**WASTEWATER TREATMENT PLANT PLANS FOR BID**

WASTEWATER TREATMENT PLANT PLANS FOR BID  
**PROCESS FLOW DIAGRAM  
 & HYDRAULIC PROFILE**  
 TOWN OF RAMAHH - PCD FILE NO. PPR2325  
 113 S. COMMERCIAL STREET  
 RAMAHH, CO 80832

WASTEWATER TREATMENT PLANT PLANS FOR BID  
**PROPOSED IMPROVEMENTS,  
 CONST. PHASING, AND DEMO**  
 TOWN OF RAMAH - PCD FILE NO. PPR2325  
 113 S. COMMERCIAL STREET  
 RAMAH, CO 80832

LIFT STATION SITE PLAN & EROSION CONTROL

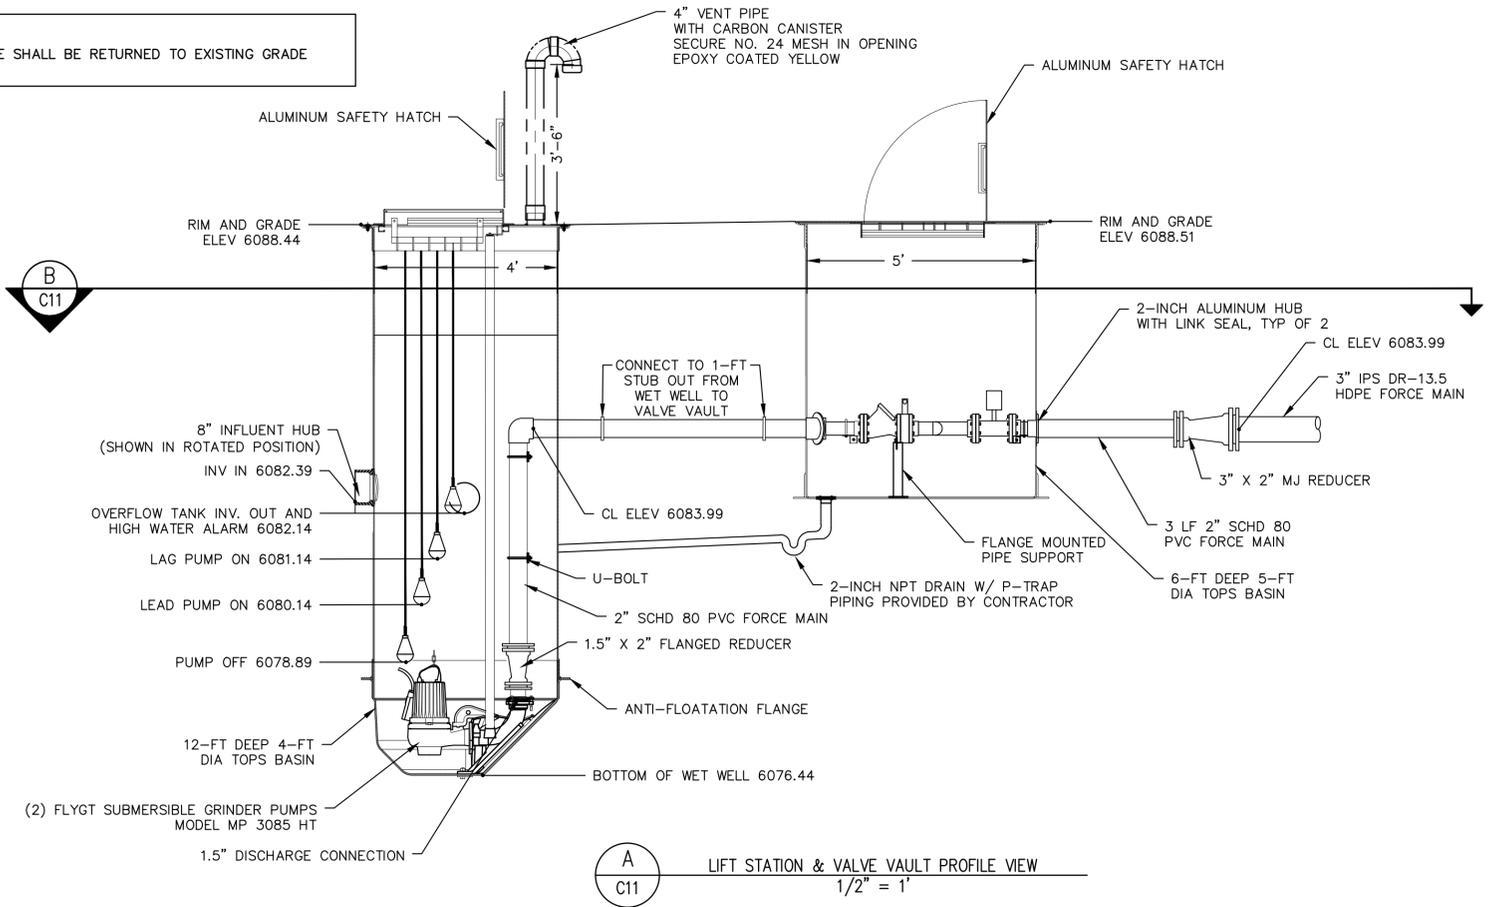
Unresolved from Submittal 1.2 - Provide details for drainage swale and discuss in detail in the drainage report. The relocated swale should have equivalent dimensions, slopes, vegetation, and inflow/outflow points as the existing swale does.

PREPARED UNDER THE DIRECT SUPERVISION OF  
 DATE: JANUARY 2024  
 JOB NUMBER: 0043.0001  
 SCALE: AS SHOWN  
 EDITION: BIDDING  
 SHEET: C13 OF C31

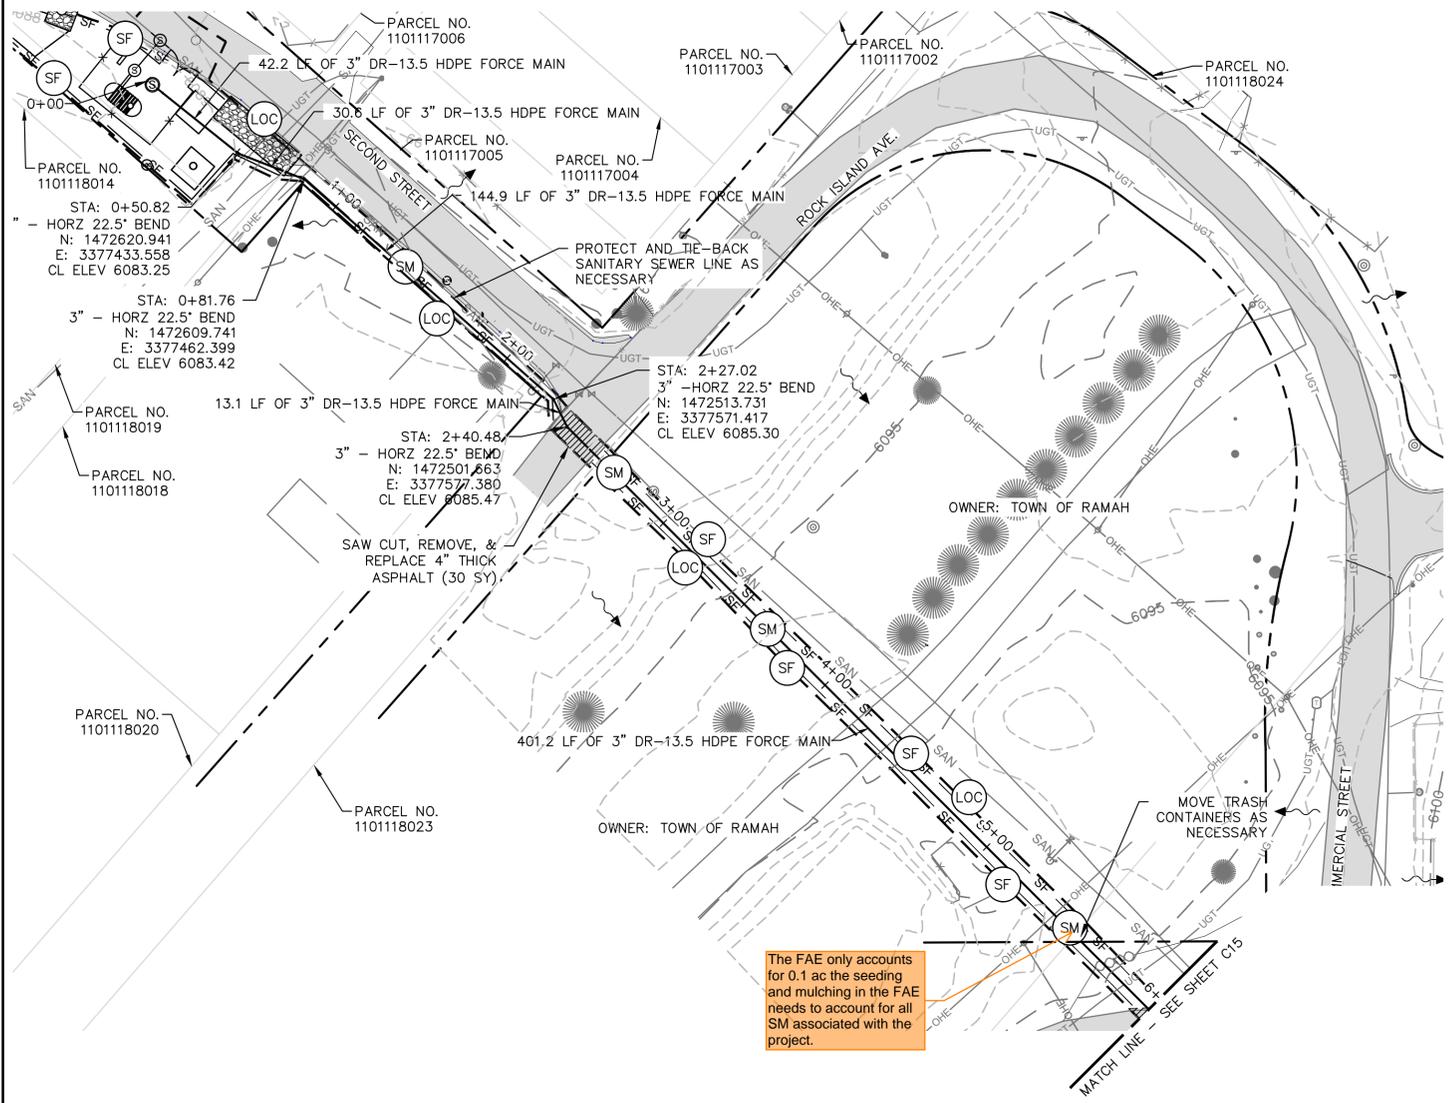
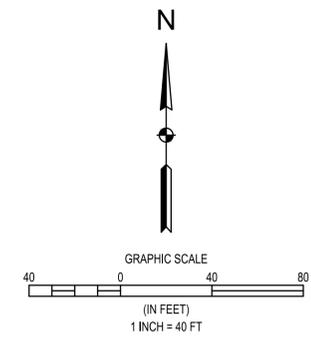
The FAE only accounts for 0.1 ac of the seeding and mulching in the FAE needs to account for all SM associated with the project.

WASTEWATER TREATMENT PLANTS FOR BID  
 HORIZONTAL CONSTRUCTION &  
 GRADING & EROSION CONTROL  
 TOWN OF RAMAH - PCD FILE NO. PPR2325  
 113 S. COMMERCIAL STREET  
 RAMAH, CO 80832

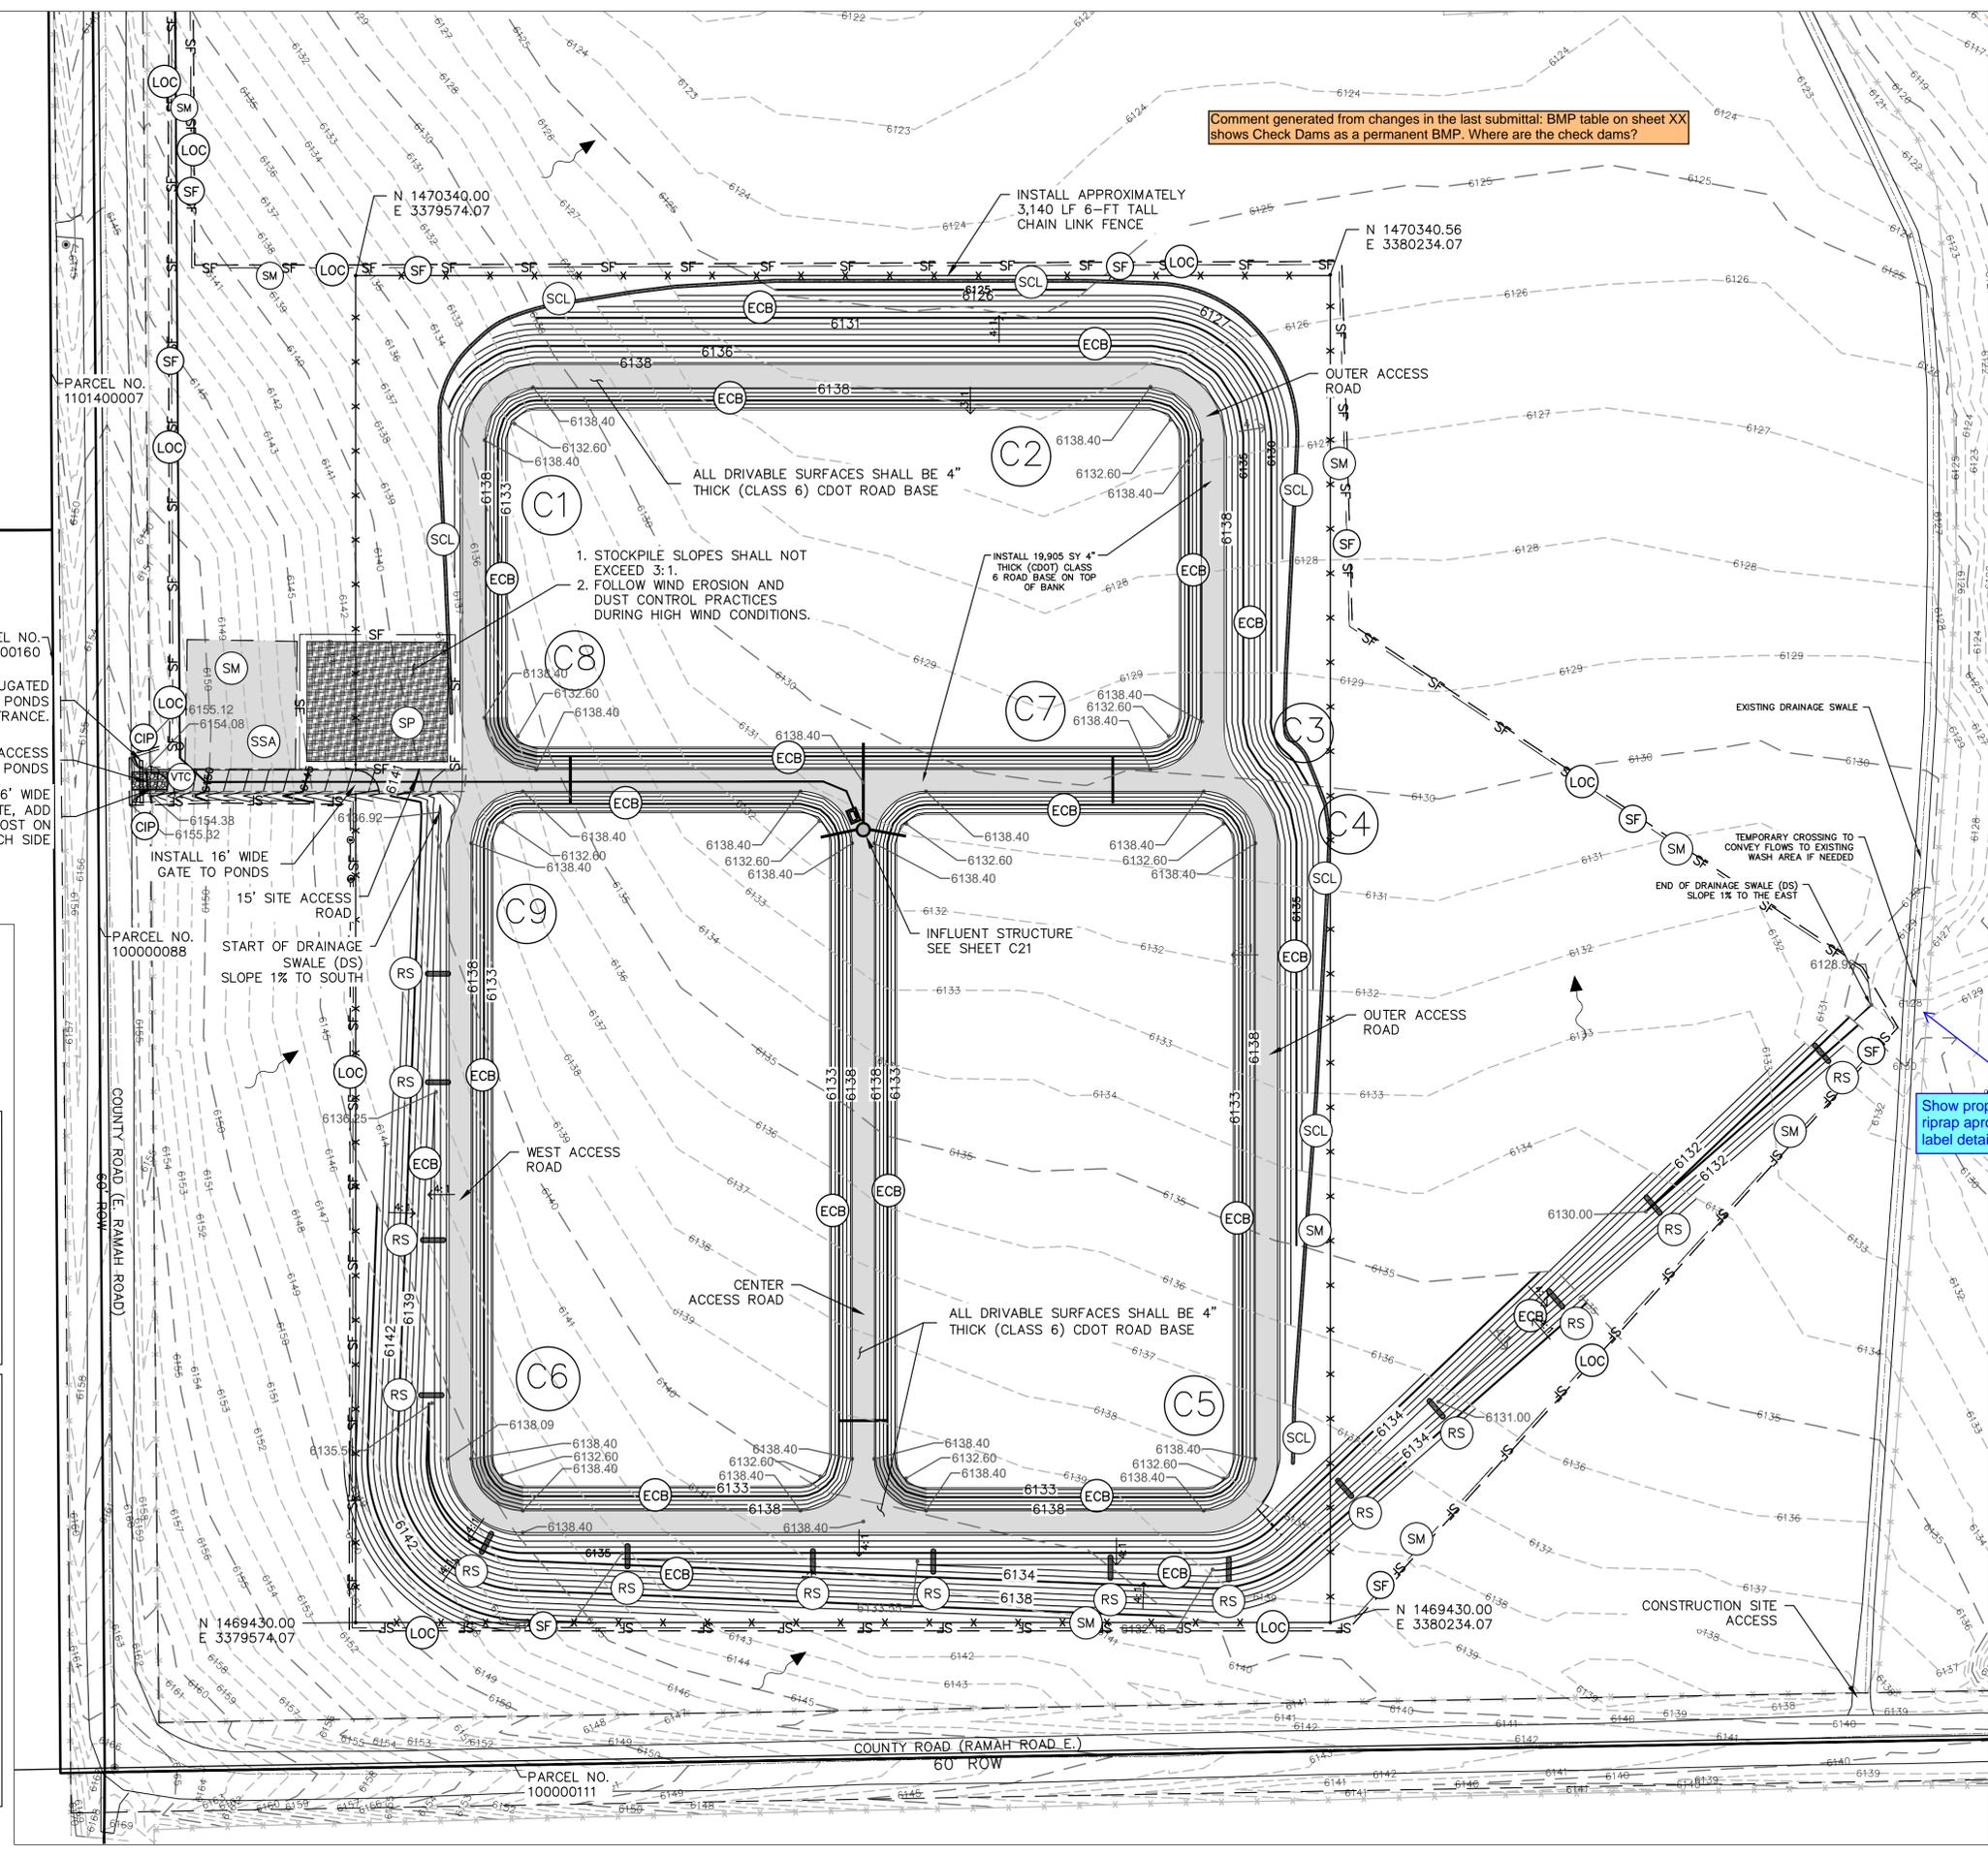
Unresolved from Submittal 1,2 - The geotechnical hazard report references a natural drainage swale in the middle of the east edge of the site that connects to an eroding gully. Show and label the existing drainageways. On page 20 of the report under the erosional features section, the report state that engineering controls should be implemented to prevent concentrated flows from the eroding existing swales from progressing the headward erosion. Show repairs and engineering control work to address this geotechnical finding.

Comment generated from changes in the last submittal: BMP table on sheet XX shows Check Dams as a permanent BMP. Where are the check dams?

Show proposed riprap apron and label details

FOR AND ON BEHALF OF  
ELEMENT ENGINEERING, LLC  
DATE  
JANUARY 2024  
JOB NUMBER  
0043.0001  
SCALE  
NTS  
EDITION  
BIDDING  
SHEET  
C29 OF C31

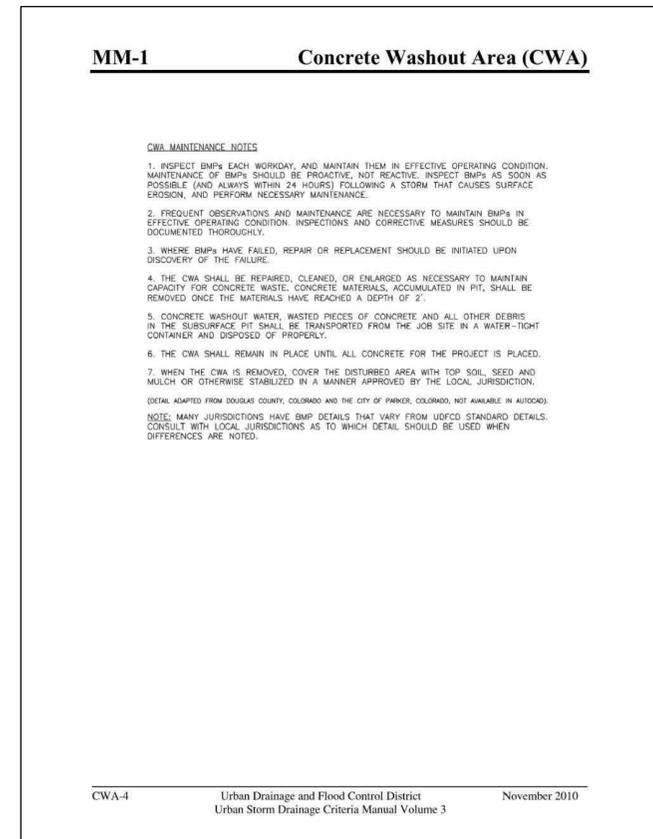
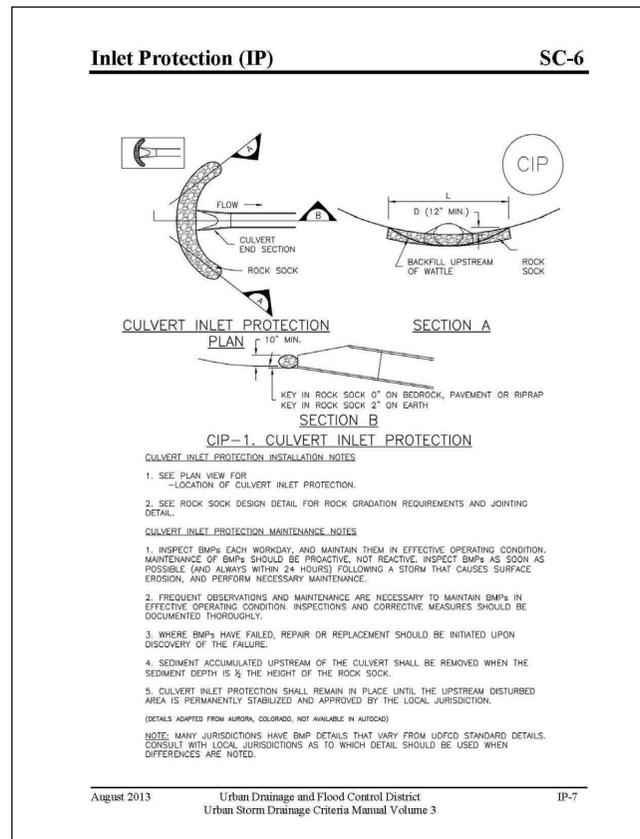
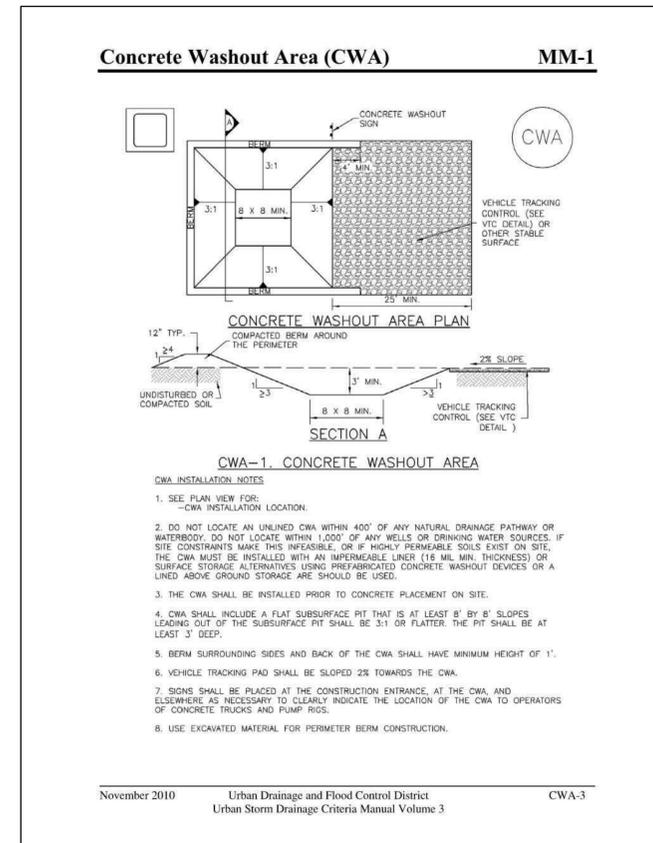
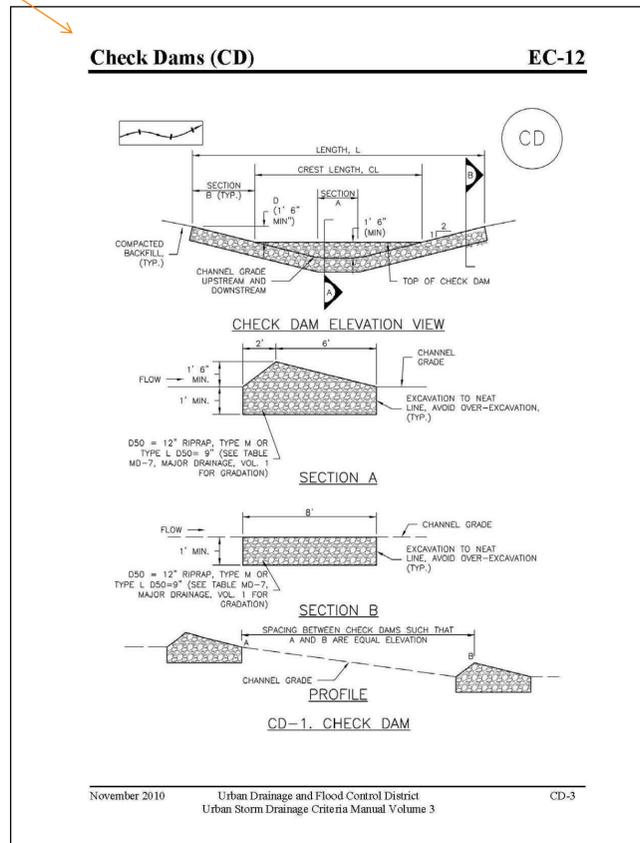
Unresolved from Submittal 2 - Provide details for: SCL SA
